Contract No. T200411209.01
Federal Aid Project No. ESTP-S028(8)
SR 24, Mulberry Knoll to SR 1
Sussex County

Enclosed is Addendum No. 1 for the referenced contract consisting of the following:

Addendum No. 1
October 24, 2019

STORMWATER MANAGEMENT PLAN DELDOT SWM FACILITY ~~#7~~ #1020 ⚠

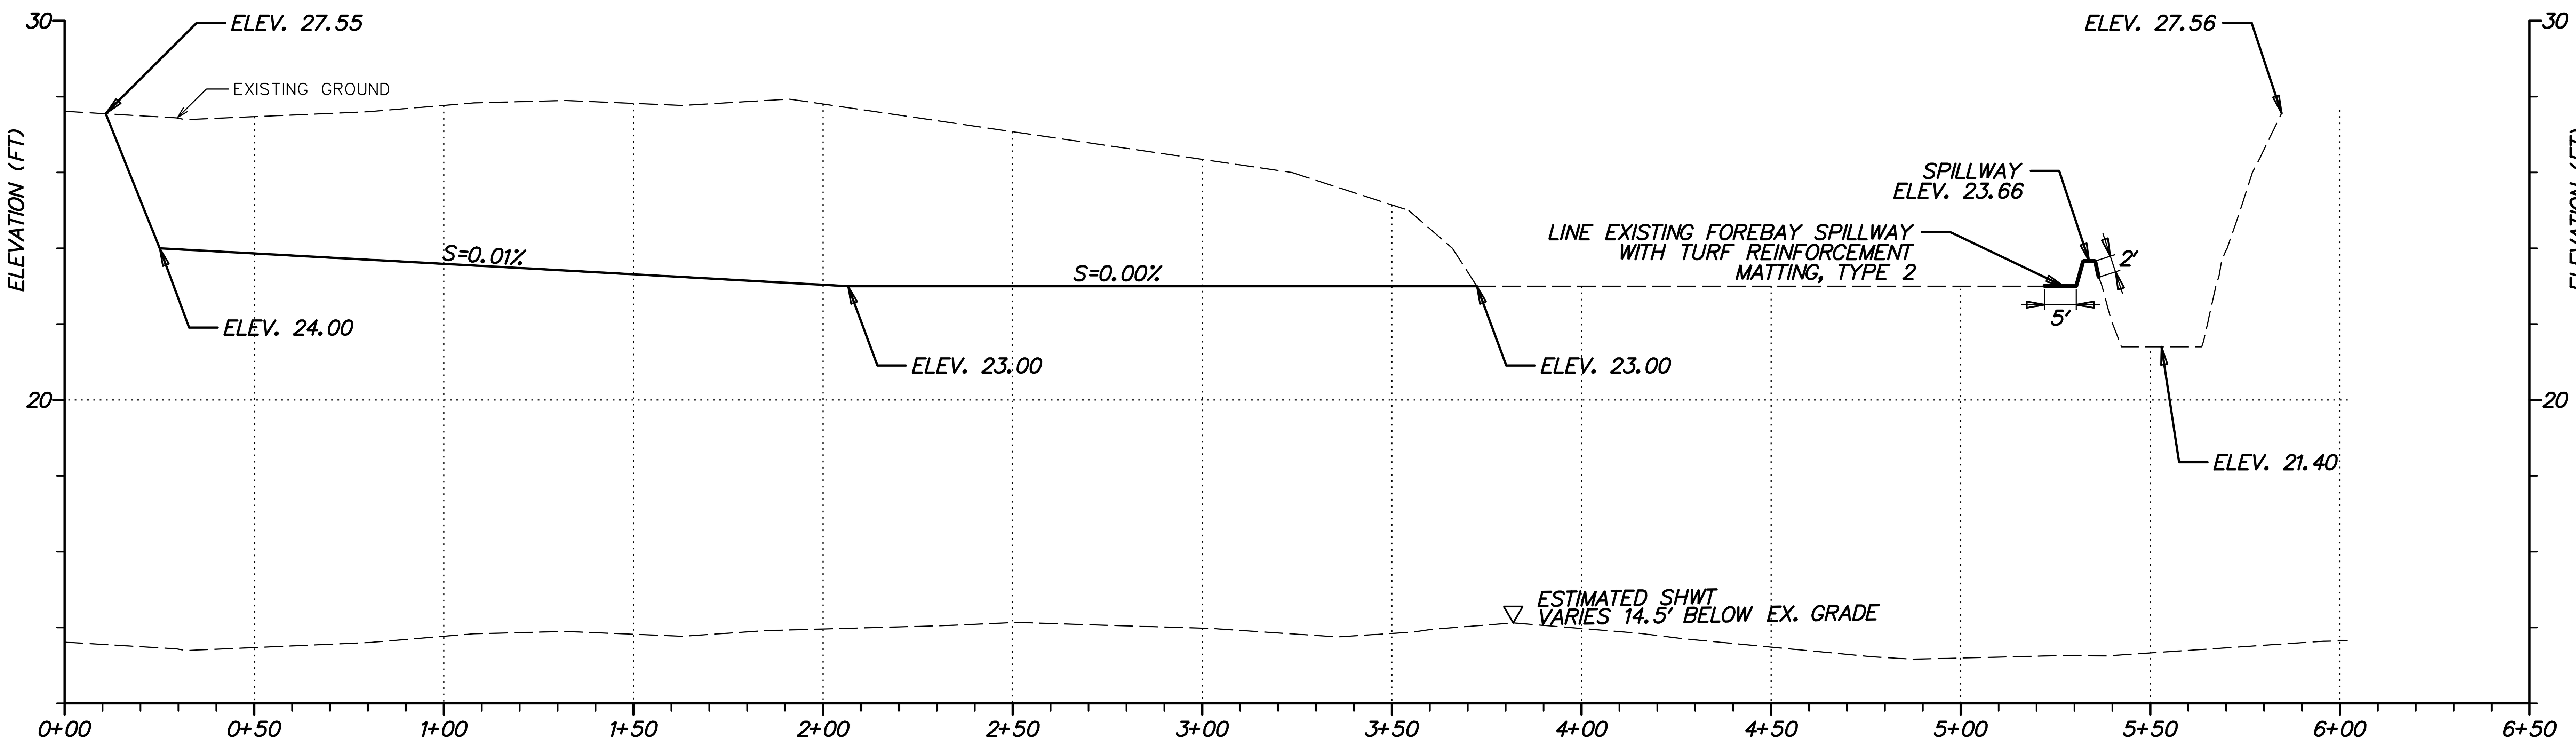
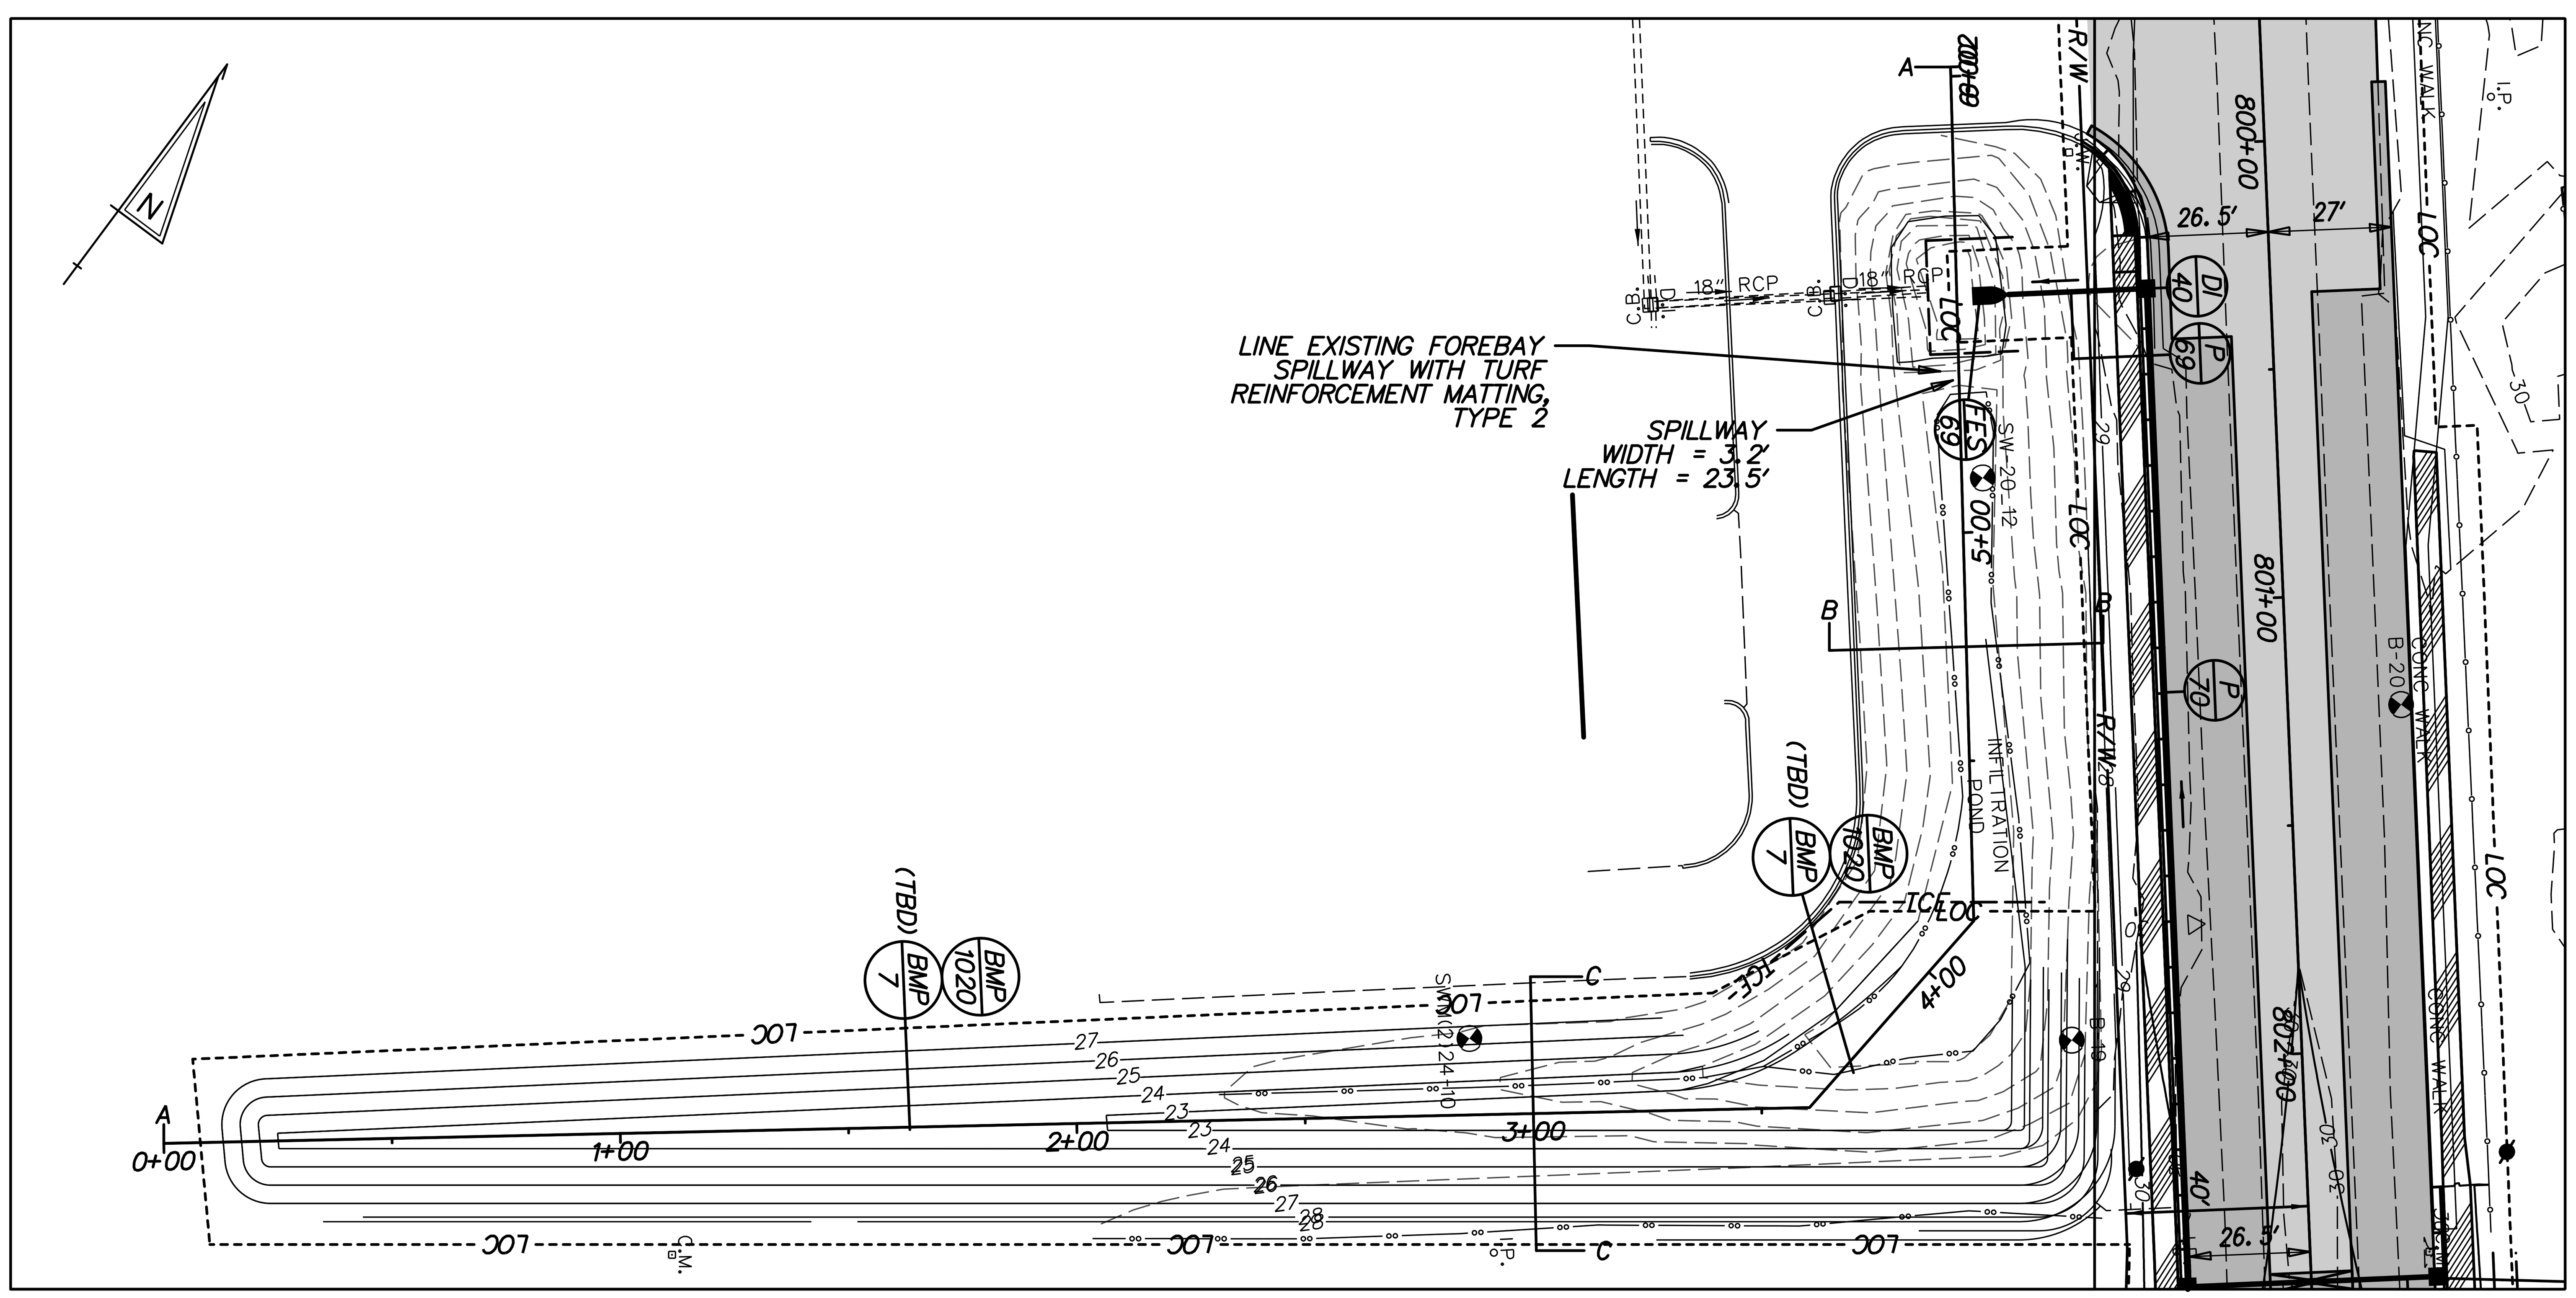
SECTION A–A – INFILTRATION BASIN – SWM BMP ~~NO.7 (TBD)~~ NO. 1020 ⚠

PLAN – INFILTRATION BASIN – SWM BMP ~~NO.7 (TBD)~~ NO. 1020 ⚠

CONSTRUCTION PHASING, M.O.T., AND EROSION CONTROL PLAN – PHASE 1

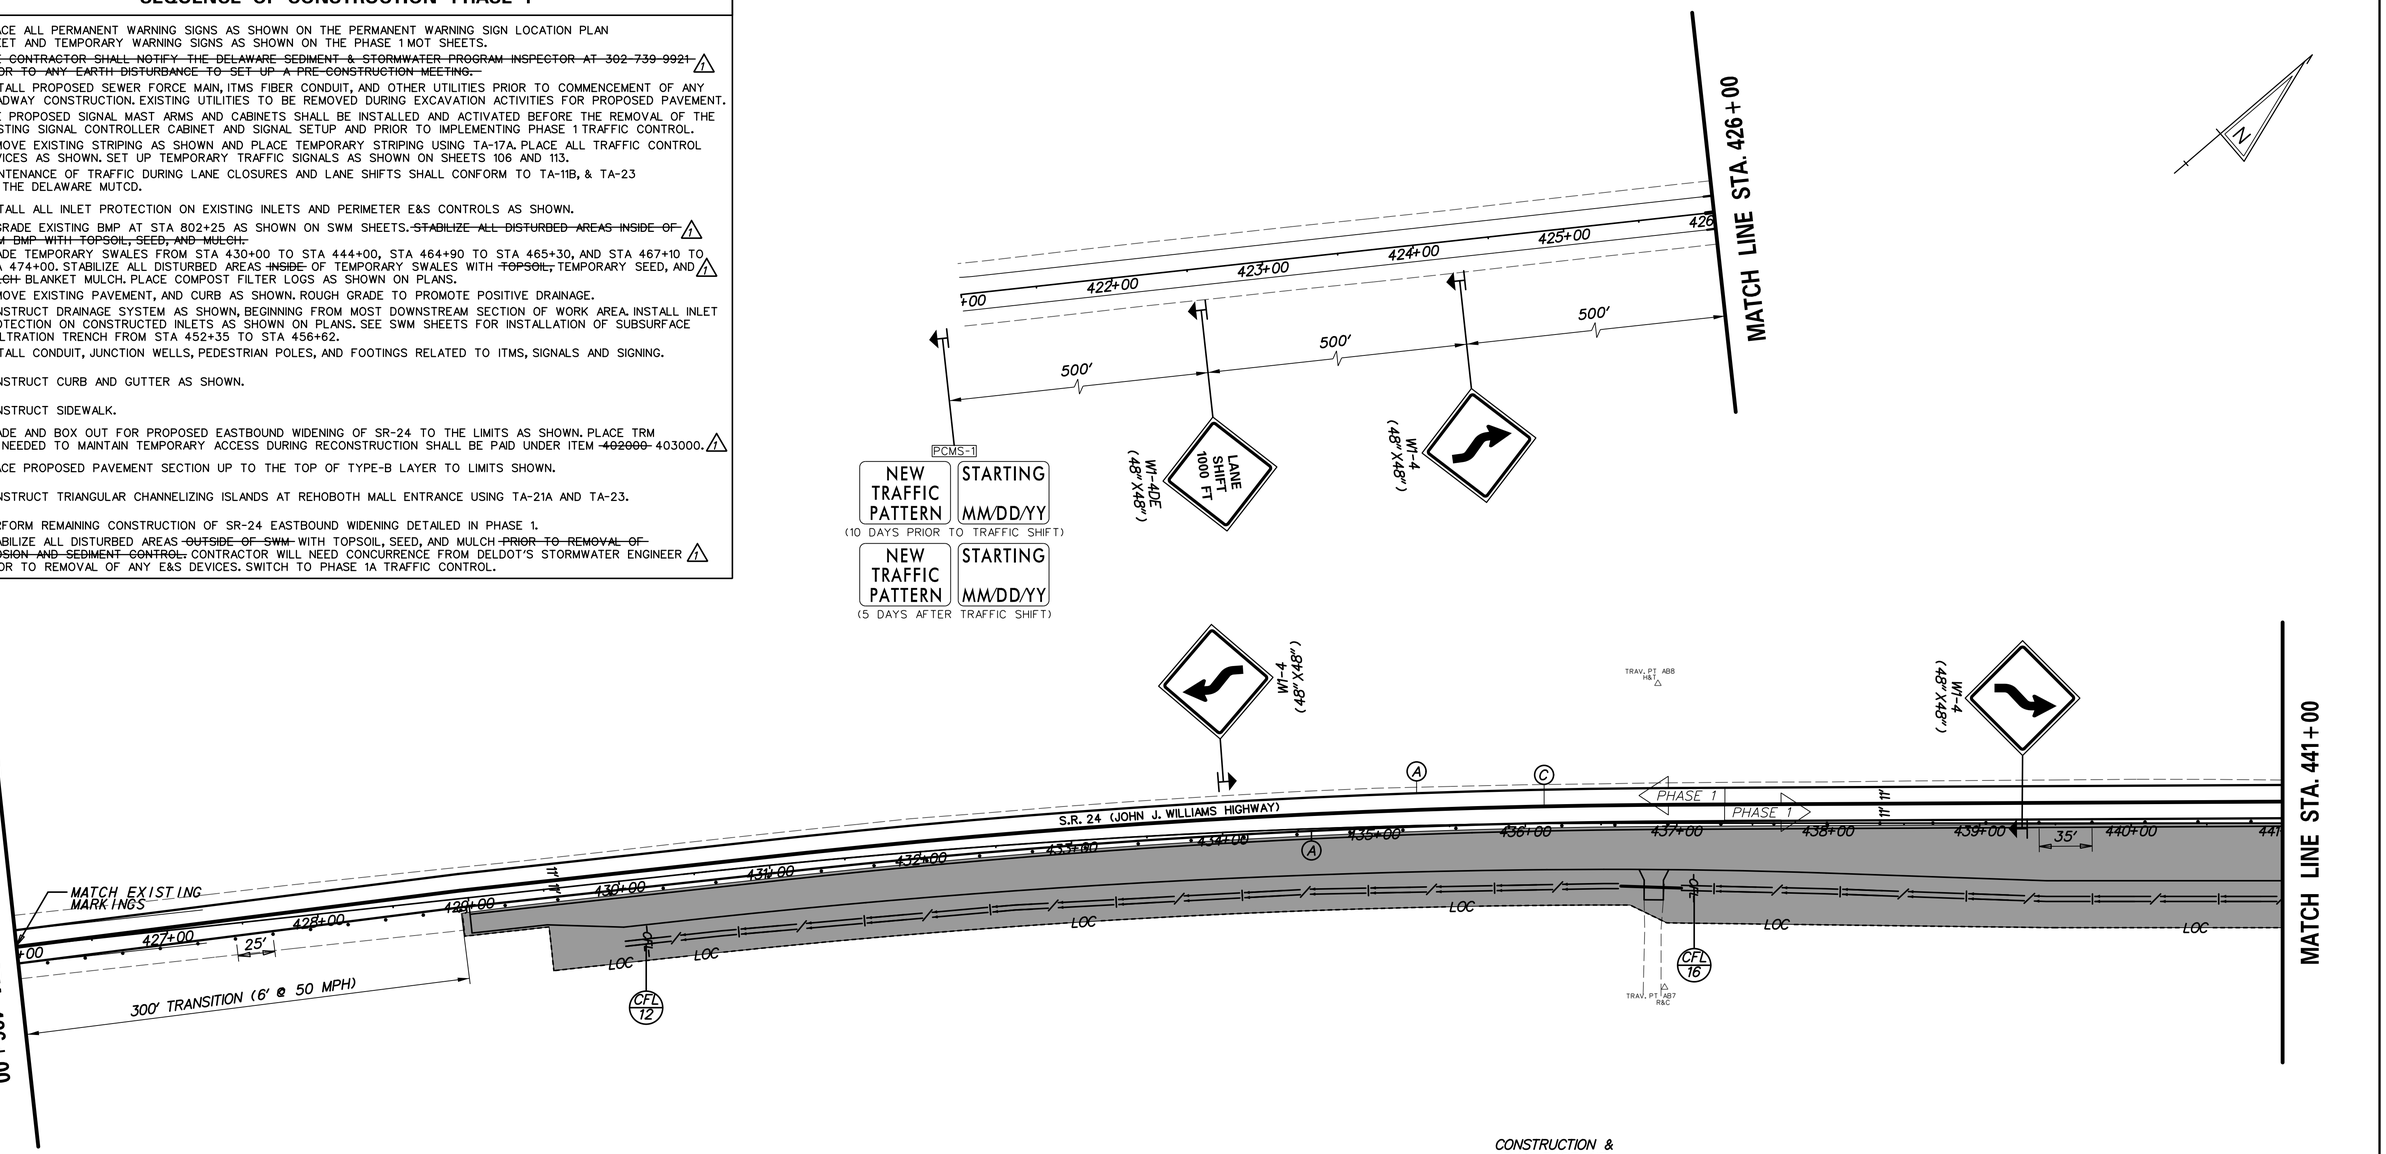
8. REGRADE EXISTING BMP AT STA 802+25 AS SHOWN ON SWM SHEETS. ~~STABILIZE ALL DISTURBED AREAS INSIDE OF SWM BMP WITH TOPSOIL, SEED, AND MULCH.~~ 1
9. GRADE TEMPORARY SWALES FROM STA 430+00 TO STA 444+00, STA 464+90 TO STA 465+30, AND STA 467+10 TO STA 474+00. STABILIZE ALL DISTURBED AREAS ~~INSIDE~~ OF TEMPORARY SWALES WITH ~~TOPSOIL,~~ TEMPORARY SEED, AND ~~MULCH~~ BLANKET MULCH. PLACE COMPOST FILTER LOGS AS SHOWN ON PLANS. 1

18. PERFORM REMAINING CONSTRUCTION OF SR-24 EASTBOUND WIDENING DETAILED IN PHASE 1.
19. STABILIZE ALL DISTURBED AREAS ~~OUTSIDE OF SWM~~ WITH TOPSOIL, SEED, AND MULCH ~~PRIOR TO REMOVAL OF EROSION AND SEDIMENT CONTROL.~~ CONTRACTOR WILL NEED CONCURRENCE FROM DELDOT'S STORMWATER ENGINEER PRIOR TO REMOVAL OF ANY E&S DEVICES. SWITCH TO PHASE 1A TRAFFIC CONTROL. 1

1	REVISED SEQUENCE OF CONSTRUCTION	D. SEMPLE 10/03/2019
